ADDENDUM NO. 02
October 31, 2025

To Drawings and Specifications dated October 17, 2025.

PKG 3D – GPHS New Batting Cages & Facility

Prepared by: PBK
11 Greenway Plaza, 22nd Floor
Houston, TX 77046-1104
PBK Project No: 240539

1 PEMB ROOF FRAMING PLAN
3/16" = 1'-0" **Kubala** ENGINEERS
P.O. BOX 2014 8774
www.kubalainc.com
TX REG. NO. F-20812

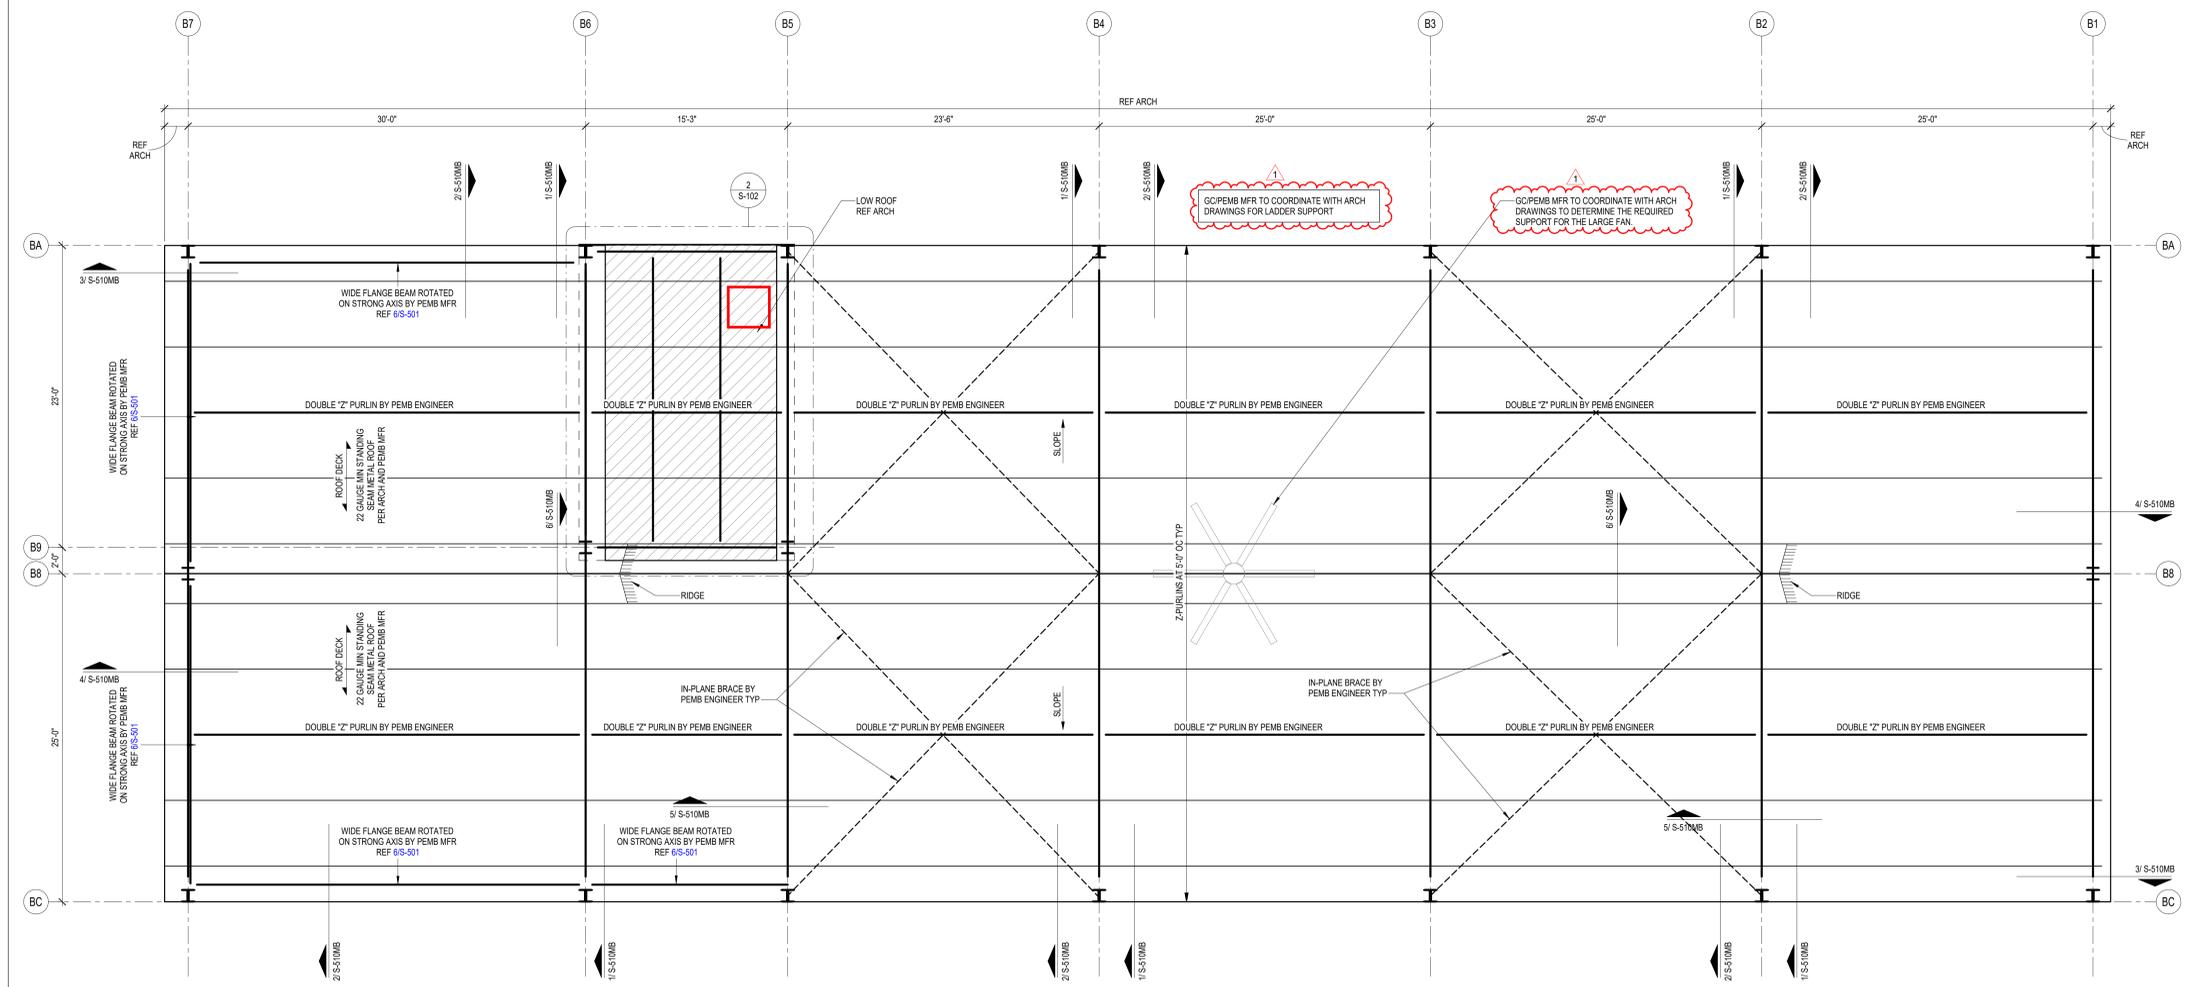
- Item No. 01 S-101 – FOUNDATION PLAN**
- 1. Added Ramp and stairs South of Grid line BC.
 - 2. Plan notes have been updated as shown in the sheet.
- Item No. 02 S-102 – ROOF FRAMING PLAN**
- 1. Added notes for large fan support and ladder.
- Item No. 03 S-302 – GRADE BEAM NOTES AND TYP DETAILS**
- 1. Grade beam depths have been updated as shown in the sheet.
- Item No. 04 S-304 – GENERAL FOUNDATION NOTES AND TYP DETAILS**
- 1. Spread footing reinforcing schedule has been updated as shown in the sheet.
- Item No. 05 S-305 – GENERAL FOUNDATION NOTES AND TYP DETAILS**
- 1. Details 5 & 6 have been added to the sheet.

06 TYPICAL LOCKER ELEVATION TYPE A
1/4" = 1'-0"

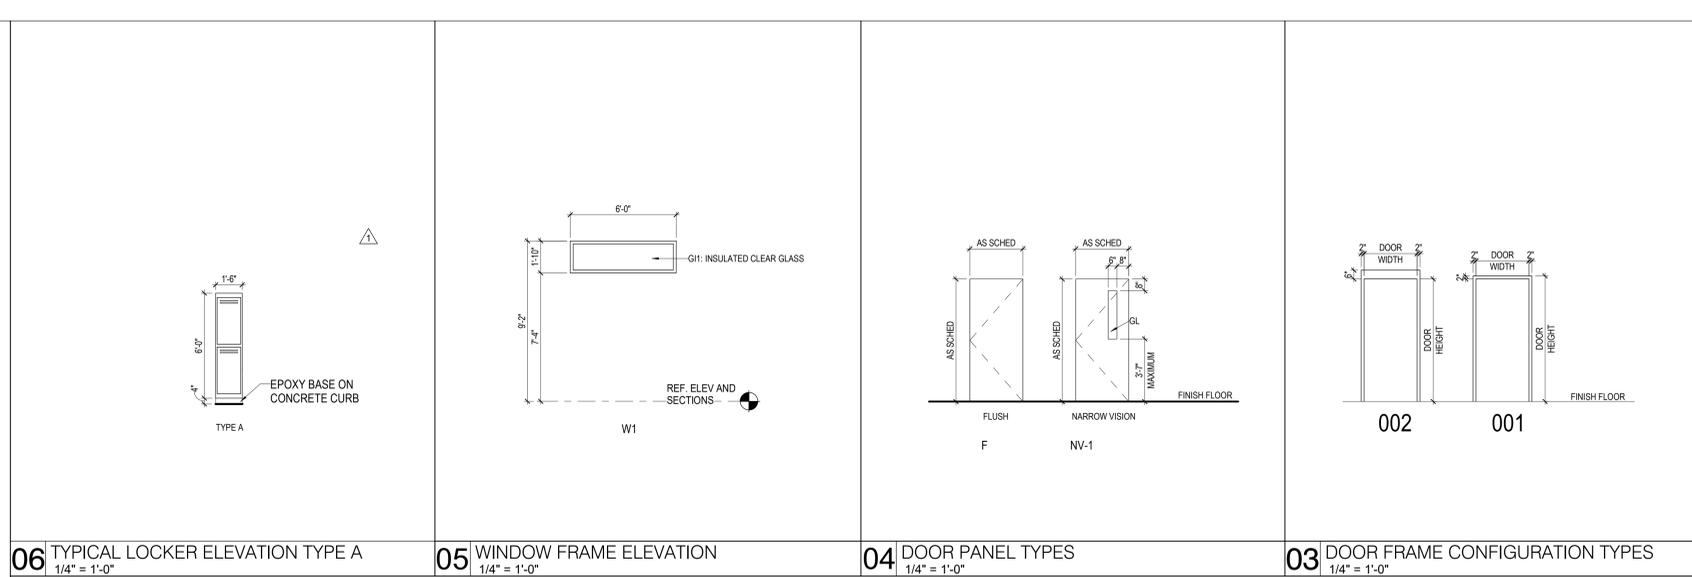
- i. Response: Please refer to ADD 01 for Alternates provided.
- Question 04: The drawings show locker type A to be 18"x18"x72" but the specs show locker type A as 34"x22"x72" and OFCI. I'm assuming we want locker Type D from the specs. Just wanted to clarify for subcontractors.

- i. Response: Please refer to revised spec 10 51 13 Metal Lockers attached.

8. ~~Color: To be selected from manufacturer's full range by Architect.~~
- B. Student Lockers Type 'F''A': Metal lockers, free-standing for base indicated on Drawings.

1. Width: 18 inches.
 2. Depth: 18 inches.
 3. Height: 72 inches.
 4. Configuration: Two tier with hooks.
 5. Ventilation: Louvers at top and bottom of door panel.

01 LEVEL 1 - FLOOR PLAN
1/8" = 1'-0"

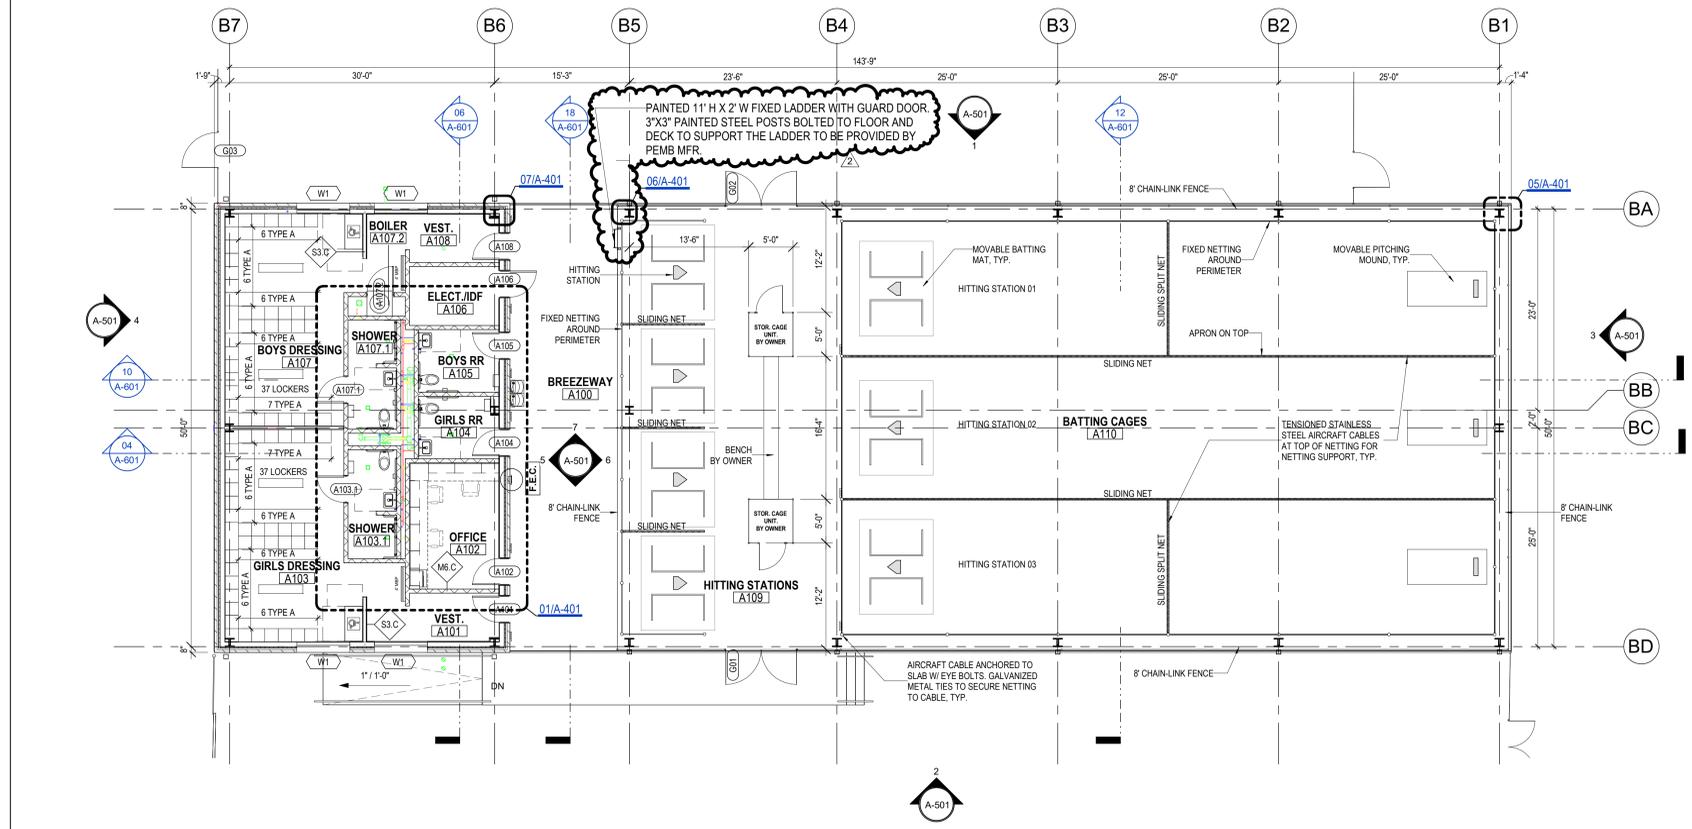
- Item No. 01 A-101 – LEVEL 1 – FLOOR PLAN**
- 1. Replace sheet in its entirety.
 - 2. Added roof hatch and ladder to plans
- Item No. 02 A-201 – LEVEL 1 – CEILING PLAN**
- 1. Replace sheet in its entirety.
 - 2. Revised ceiling plan and ceiling materials legend.
 - 3. Revised ceiling detail 02.
- Item No. 03 A-501 – EXTERIOR ELEVATIONS**
- 1. Replace sheet in its entirety.
 - 2. Added elevations 6 & 7.
- Item No. 04 A-601 – BUILDING SECTIONS & WALL SECTIONS**
- 1. Replace sheet in its entirety.
 - 2. Revised sections 4, 10, 11, & 16.
- Item No. 05 A-602 – WALL SECTIONS & PARTITION TYPES**
- 1. Replace sheet in its entirety.
 - 2. Revised details 5, 6, 7, & 8.
 - 3. Deleted details 9 & 10

1 1ST FLOOR MECHANICAL PLAN - BATTING CAGE & NETTING PLANS
1/8" = 1'-0"

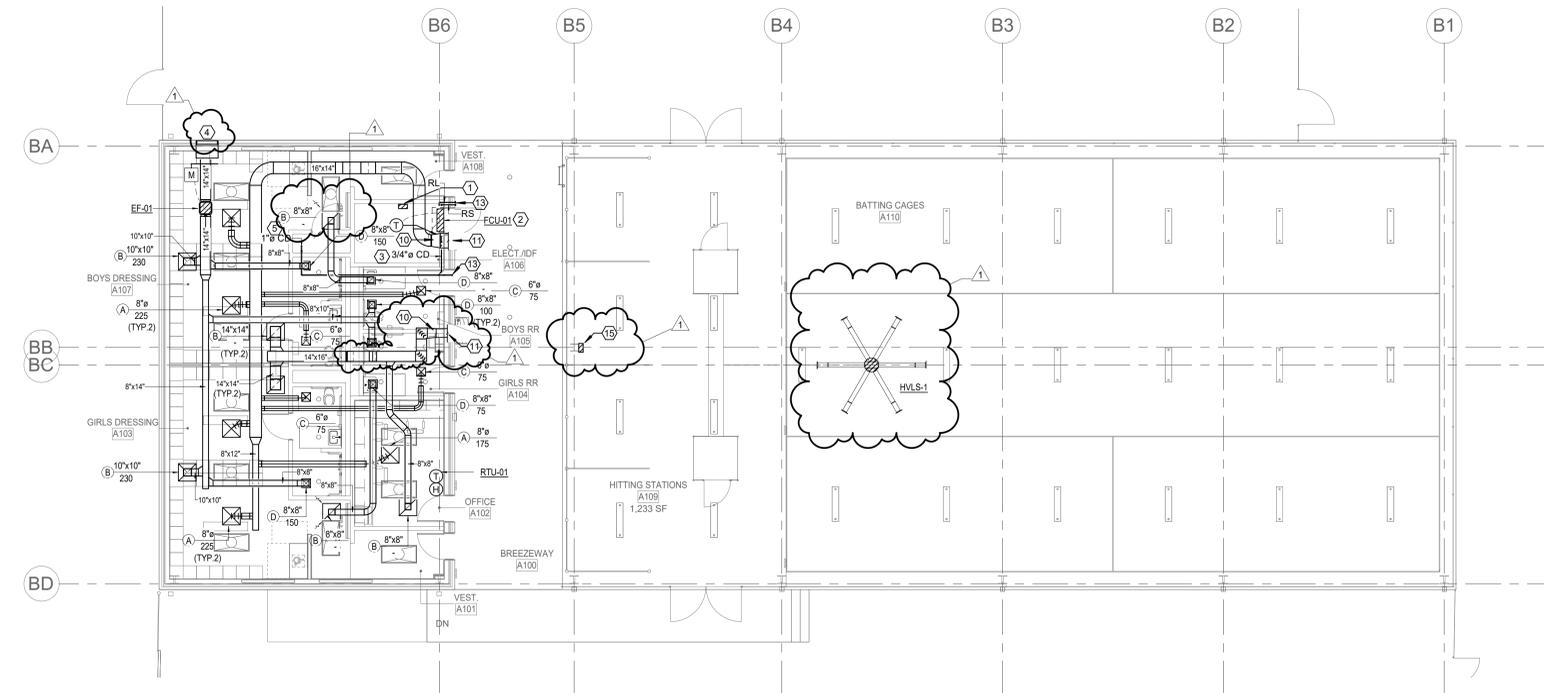
Item No. 01 M-101 – 1st FLOOR MECHANICAL PLAN – BATTING CAGES & NETTING PLANS

1. 01/M-101 – added HVLS-01 and wall mounted switch serving batting cage and hitting stations
2. 01/M-101 – Updated RA ductwork routing into space due to structural conflicts.
3. 01/M-101 – Corrected Keynote number by louver
4. 01/M-101 – Corrected Return Grille label for grille in A107-Boys Dressing
5. 02/M-101 – Updated routing of RA ductwork into building due to structural conflicts.
